ENGINE - DEDICATED ALTERNATOR ROTOR - INTRODUCTION OF NEW SOURCE OF SUPPLY - CATEGORY  
CODE 7 - MOD.ENG-72-0228

V2500-ENG-72-0228

LOCATION OF DEDICATED ALTERNATOR ROTOR  
Fig.1

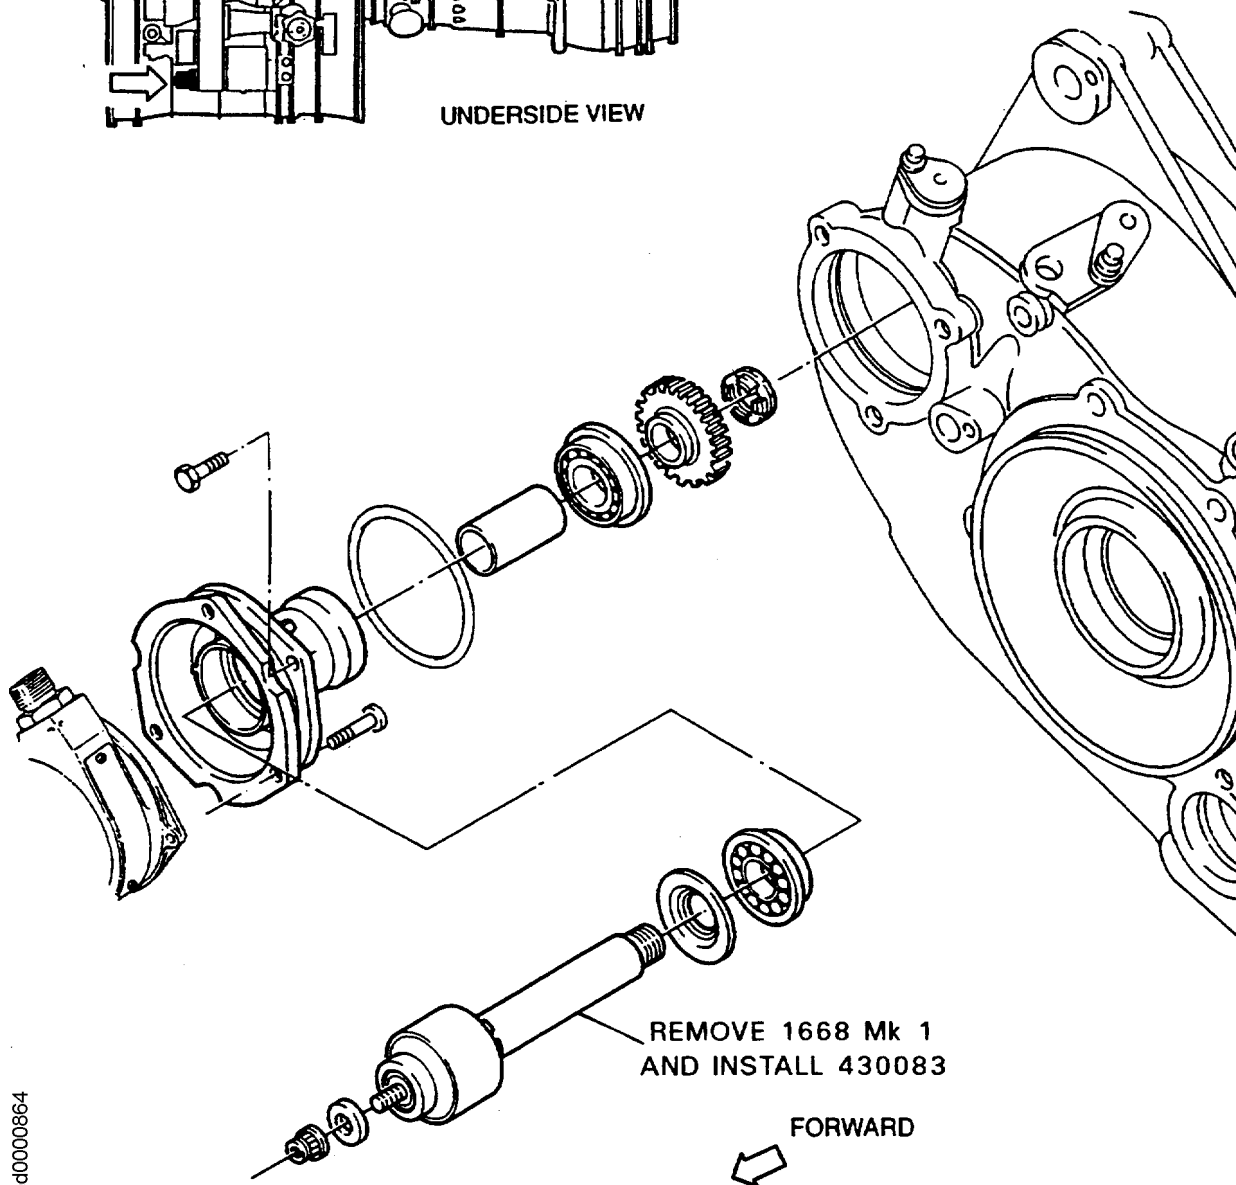
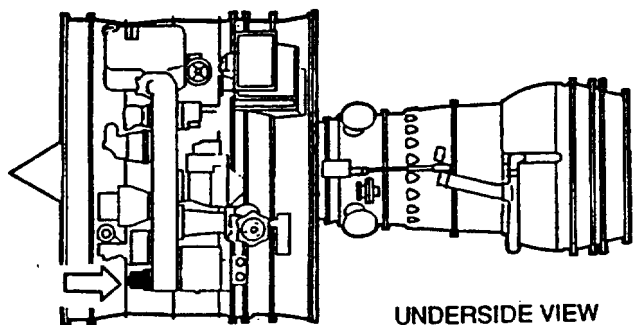
Incorporation of this Service Bulletin is designed to introduce a new source of supply for the Engine Dedicated Alternator Rotor.

- (1) This Bulletin covers the introduction of a new Engine Dedicated Alternator Rotor supplied by B.F. Goodrich.
- (2) Units introduced by this Bulletin will be identified by the type number 430083.

- (1) Install the new 430083 Dedicated Alternator Rotor as instructed in Reference (1), TASK 72-60-10-440-001, SUBTASK 72-60-10-440- 084.
